Intel® 82443MX PCIset

Specification Update

February 2003

Document number: 245051-008

Figure 1: Successful Self-refresh Entry

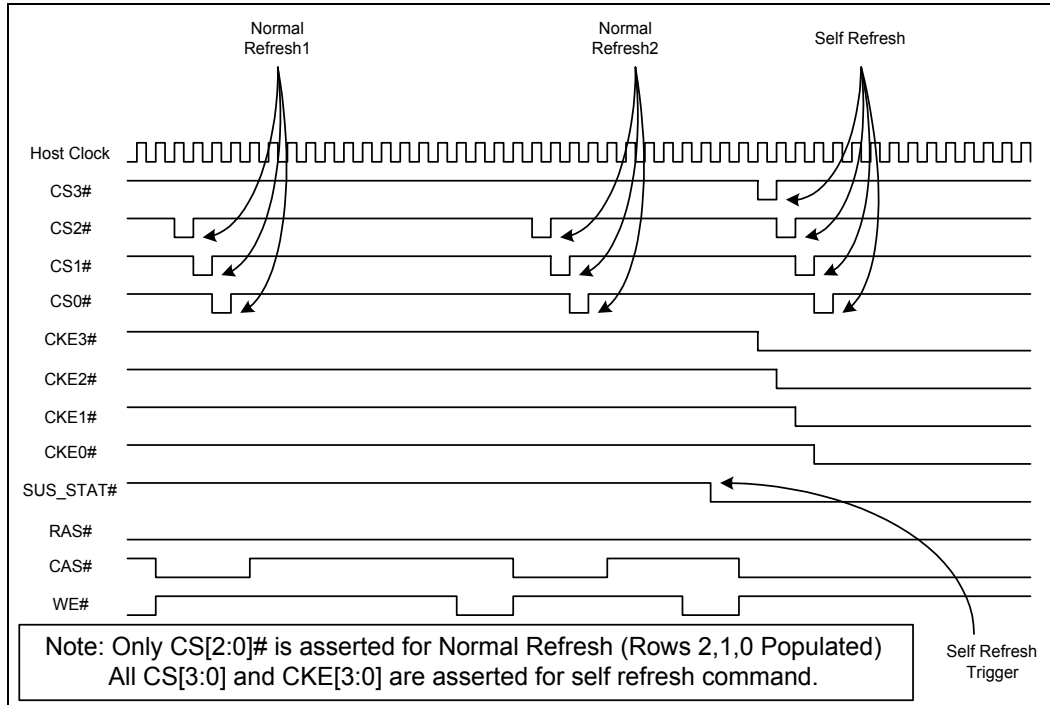
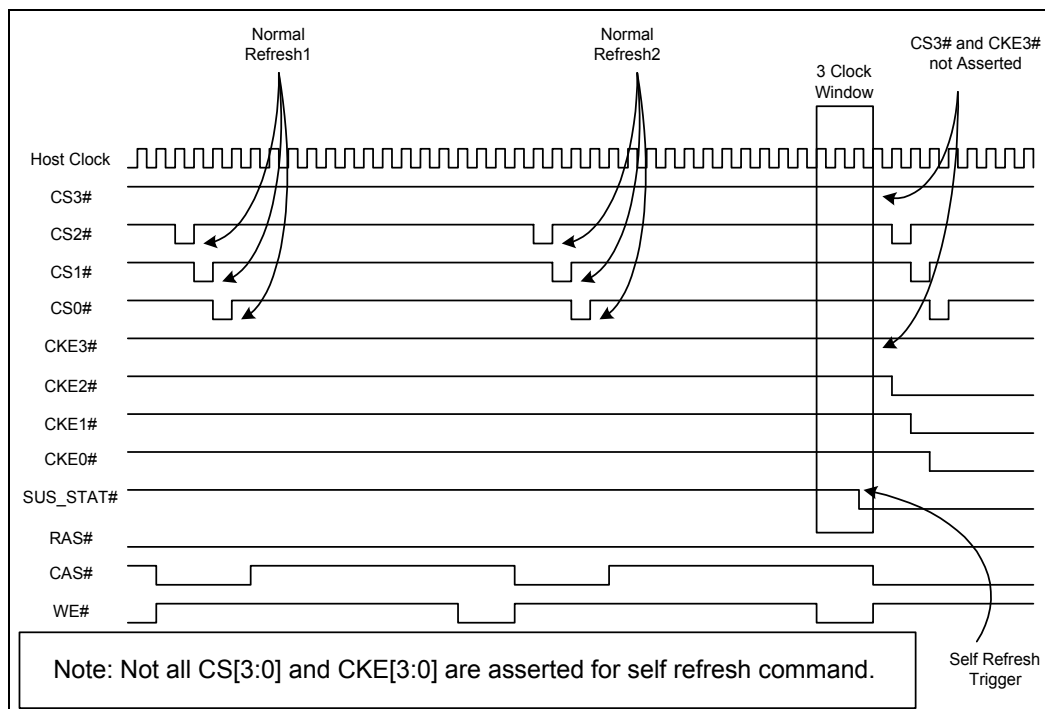
9. C3/POS/STR Memory Hang Condition

Issue: SDRAM may be prevented from being put into self-refresh state when a self-refresh entry request triggered by SUS_STAT# assertion collides with a normal refresh caused by internal timer expiration. The collision between the two requests results in anomalous behavior on the CS[0-3]# and CKE[0-4]#, which can cause the system hang/memory corruption. There is a three Host clock window in which the assertion of SUS_STAT# can cause this failure.

Figure 2 illustrates an unsuccessful self-refresh entry sequence. Note that SUS_STAT# is being asserted approximately the same time that the third normal refresh would have taken place. Since the SUS_STAT# assertion hits the three host clock window, CS3# and CKE3# do not get asserted during the self-refresh entry sequence.

Implication: The system may hang if an unsuccessful self refresh entry sequence occurs.

Workaround: Please refer to the SDRAM Suspend Refresh Erratum APM Workaround Write-up, Rev 1.0 for a software workaround solution.

Figure 3: Errata 33, Workaround #4: USB Device Attach/De-attach - Hardware Solution

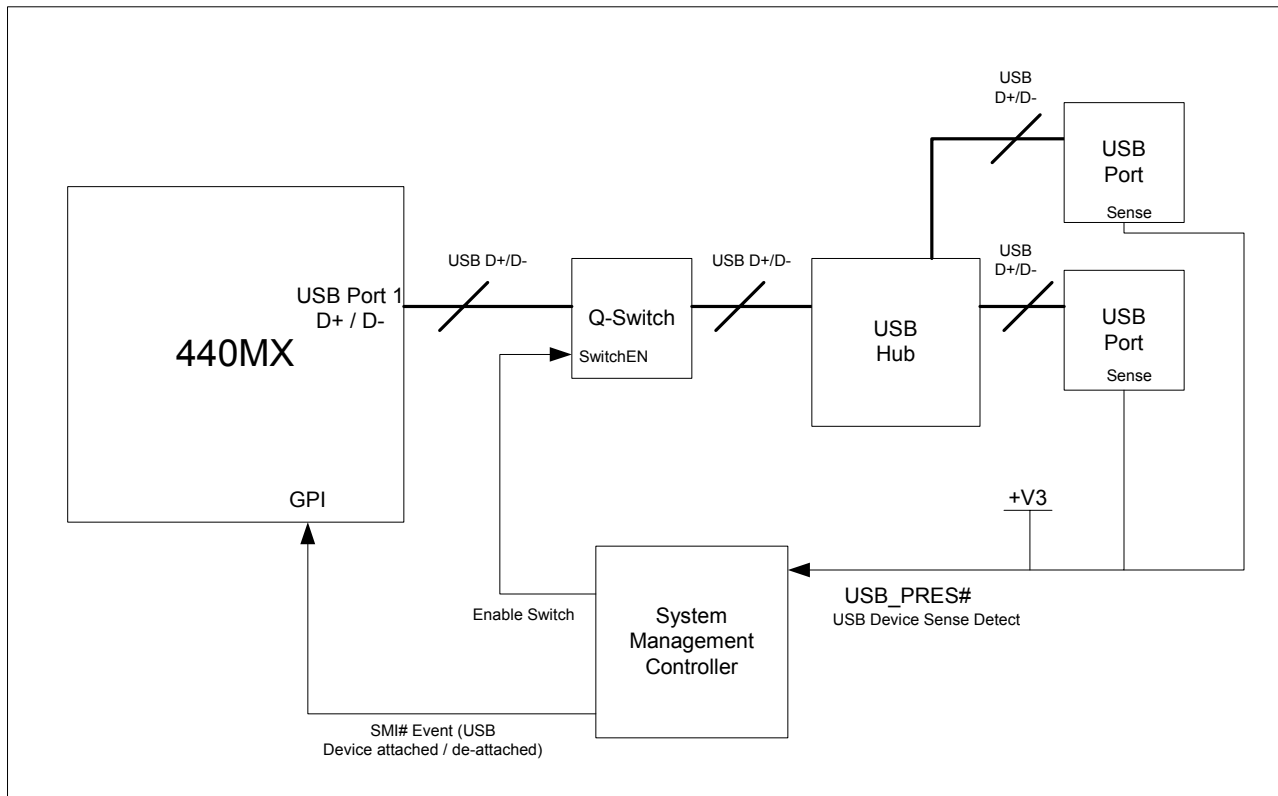
33. USB Connect Status Change Bit does not get set under certain conditions

Issue: When system is in S0 state with CLKRUN# enabled and PCI bus is idle (and hence STP_PCI# is asserted), the USB Connect Status Change Bit does not get set.

Workaround Option #4: USB Device Attach/De-attach Hardware Detect

Circuitry can be implemented to allow the chipset to enter a power management state with an on-board USB hub. The 5th pin of each of a USB connector with “sense detect” is used to sense a USB device’s presence (Note: not all USB ports have a 5th pin for sense detect, check part specification for details). The sense detect pins are wired together to form one signal USB_PRES# and connected to the System Management Controller (SMC). When there is no USB device connected, the 5th pin on the USB connector is floating and therefore the signal is pulled up to +V3_USB. When a USB device is plugged into any one of the USB connectors, the connector’s 5th pin is grounded, pulling USB_PRES# low. When the USB_PRES# is pulled low, the SMC alerts the chipset via an SMI# and then enables the 2-bit Q-Switch which connects 440MX USB port to the on-board USB hub (see Figure 3 below). The Hub will identify itself to the chipset. When the chipset recognizes the hub, the hub informs the chipset of any devices connected to it (i.e., the device attached that caused USB_PRES# to be pulled low). When there are no devices connected to the USB connectors, the SMC disables the Q-Switch, which disconnects the on-board USB hub from the chipset and therefore allows the processor to enter power management states such as C3.

Waveform of Fast Reset Test Mode

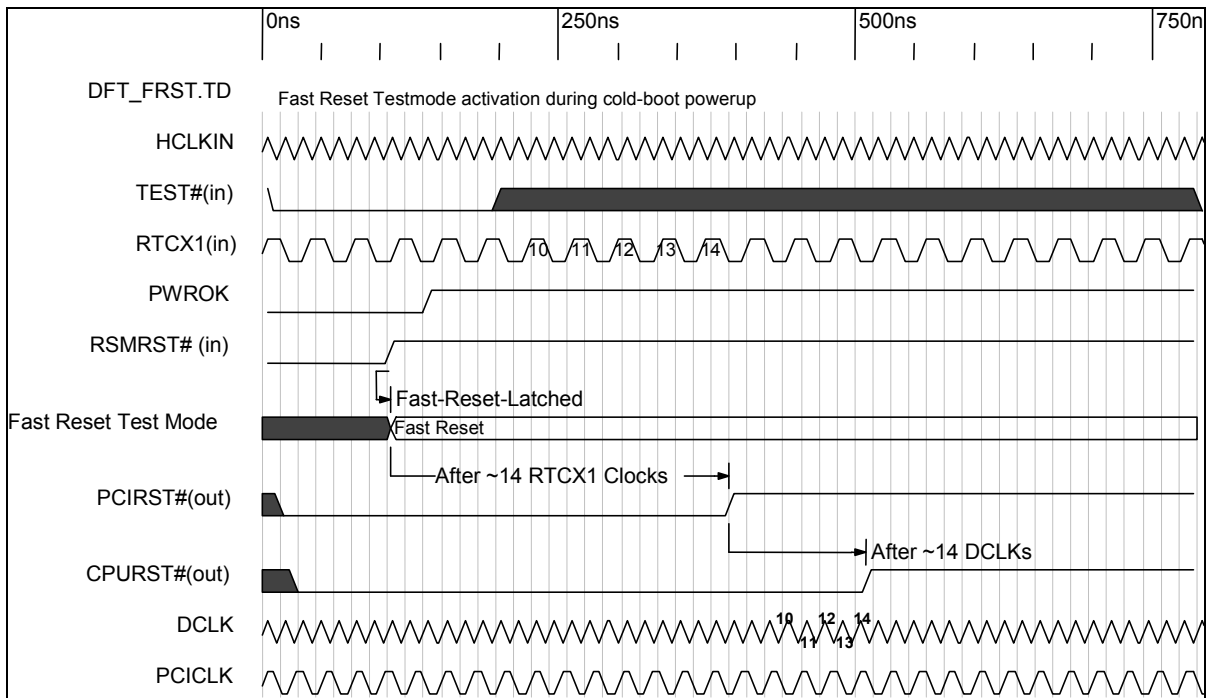
The Fast Reset test mode is activated (i.e. Latched) if TEST# is driven '0' at the rising-edge of RSMRST#. In Fast Reset test mode, the CPURST# is only asserted for ~14 DCLKs after PCIRST# is sampled de-asserted. The following timing diagram illustrates these relationships

Waveform of NAND Tree Test modes

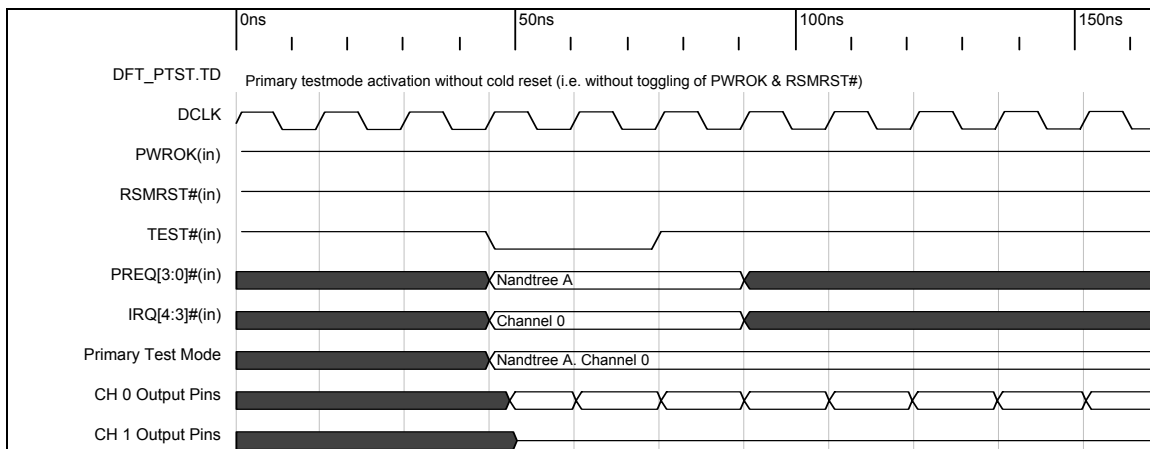
To enter the part into a NAND tree mode it is recommended that the appropriate values on PREQ[3:0]# be driven from the beginning in order to Latch-in the desired NAND tree test mode simultaneous to the execution of the Fast-Reset test mode. This avoids toggling of the TEST# pin multiple times.

The following timing diagram shows the exact sequence required to enable NAND tree test mode. Note that the TEST# input pin acts as a latch enable, whereas the PREQ[3:0]# and IRQ[4:3]# pins act as latch inputs. The test mode is decoded from the output of the latch.
